Ground Gas Mitigation: Verification Inspection Report

Pearsons Close
(Prev. 128 Barrier Bank),
Cowbit, Spalding, PE12 6AL

Issue 2

March 2026

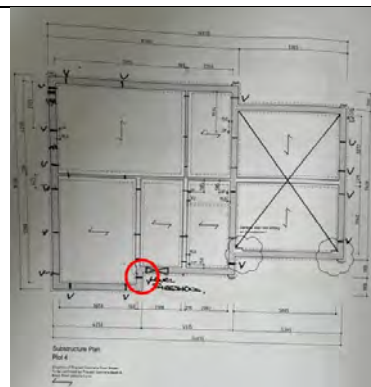
Plot 2. Areas highlighted are where telescopic vents are missing due to door / threshold coordination issues.

Plot 2. Area where the 2 telescopic vents are missing due to door / threshold coordination issues.

MEC observed that telescopic vents and air bricks have been constructed per the venting layout plans, with the exception of Plot 2 (where 2 No. vents / air bricks had been omitted due to a coordination issue with door / threshold detailing) and Plot 4 (where 1 No. vent / air brick has been omitted, presumed by error). Revised ventilation calculations were completed by East Anglian Civils Limited for Plots 2 and 4 (see Appendix C). These confirm the as-built venting provision to exceed requirements by 32% at Plot 2 and 41 % at Plot 4. As such, retrospective installation of the missing vents is not considered to be required.

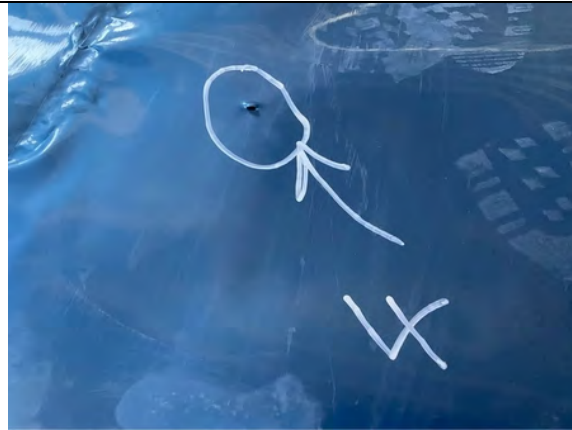
Plot 1. Recorded defect.

Plot 1. Defect patched with Juta GP1 SAM and probe tested.

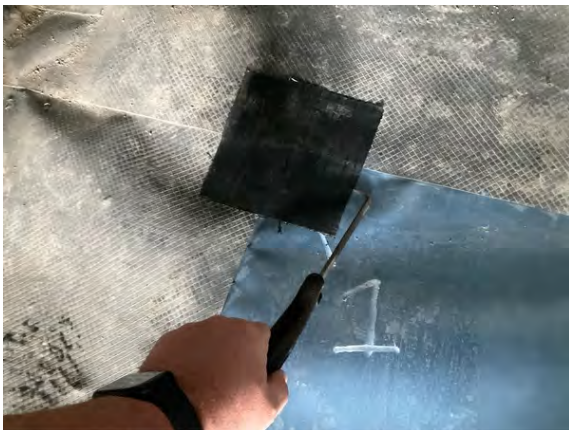
Plot 4. Recorded Defect.

Plot 4. Defect was patched repaired using Juta GP1 SAM and then probe tested.

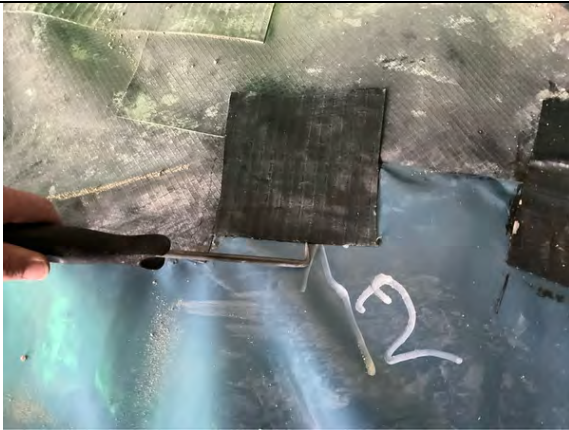
Plot 4. Recorded Defect.

Plot 4. Defect was patched repaired using Juta GP1 SAM and then probe tested.

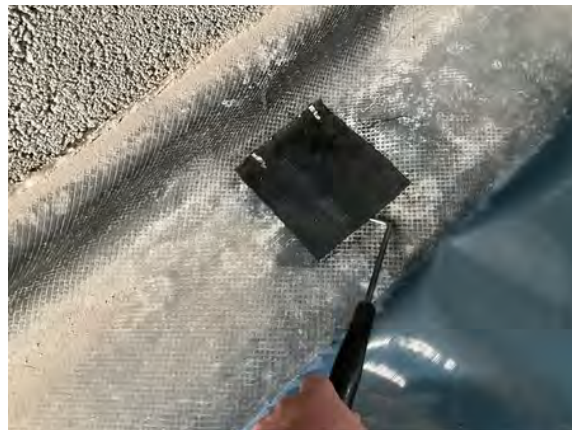
Plot 4. Recorded Defect.

Plot 4. Defect was patched repaired using Juta GP1 SAM and then probe tested.

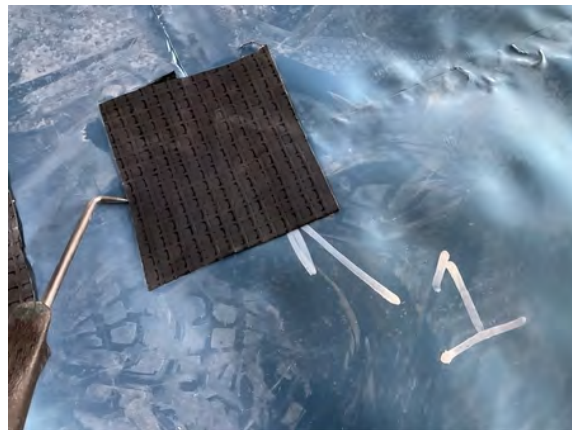
Plot 5. Recorded Defect.

Plot 5. Defect was patched repaired using Juta GP1 SAM and then probe tested.

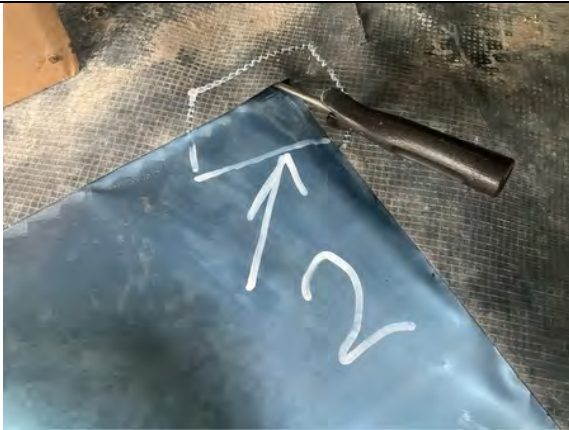
Plot 5. Recorded Defect.

Plot 5. Defect was patched repaired using Juta GP1 SAM and then probe tested.

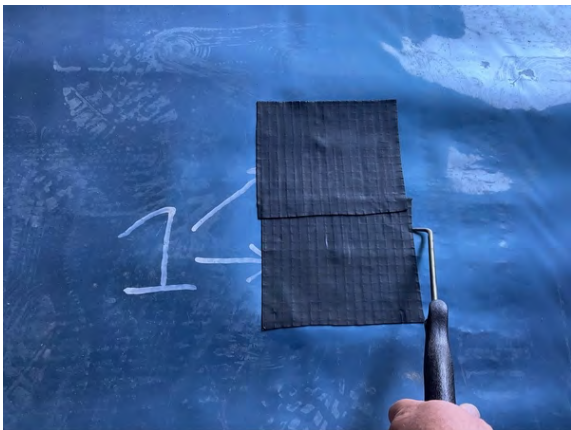
Recorded Defect.

Recorded defect was patched repaired using Jute GP1 SAM.
